Government of India  
Ministry of Railways  
Research Design & Standard Organisation  
Manak Nagar, Lucknow – 226 011

Modification Sheet No. ELRS/ MS / 0322

Modification of RC damping panel on the locomotive provided with Static converter of air brake/ dual brake ac Electric locomotives.

(MODIFIED CIRCUIT)

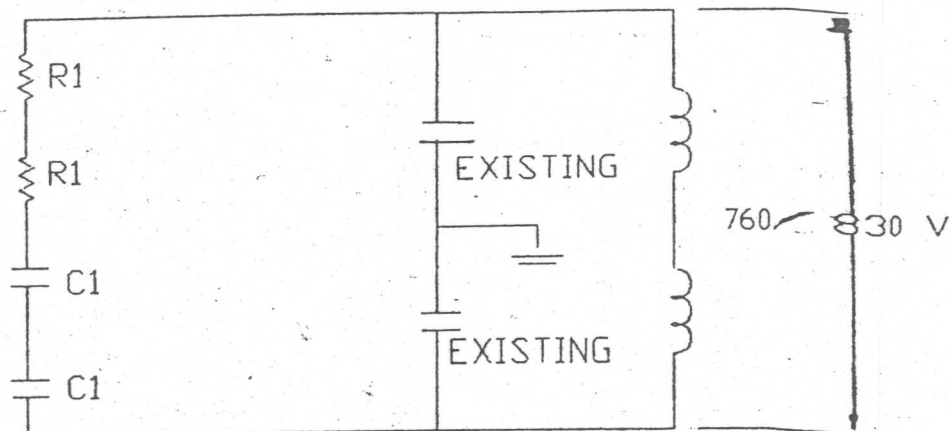
The RC damping panel being supplied by the VCB manufacturers as a part of the equipment consists of THREE RC networks, (the ohmic value of each resistance being 4.7 ohms and value of each Capacitor as 25 micro farad) and they have been connected in parallel across the tertiary winding of transformer (a0 –a1) when working with conventional Arno converter. The rated voltage of these capacitors is 560 volts.

Now with static inverter since input voltage is higher i.e.830, it is necessary to connect two existing RC networks in series across the series connected coils of tertiary winding (a7-a8). This will suffice the requirements of surge suppressor. The third branch of the RC network may be removed or kept disconnected.

The capacitors CAPTFWA1 and CAPTFWA2 with their center point earthed will also be connected across the series connected coils of tertiary winding (a7-a8).

- a) To connect two existing RC networks (the ohmic value of each resistance being  $4.7 \Omega$  380 Watt and value of each capacitors as  $25 \mu f$  560 Volt) in series across the series connected coils of tertiary windings (a7-a8).

- a) The third branch of the RC network if available may be removed or kept disconnected.
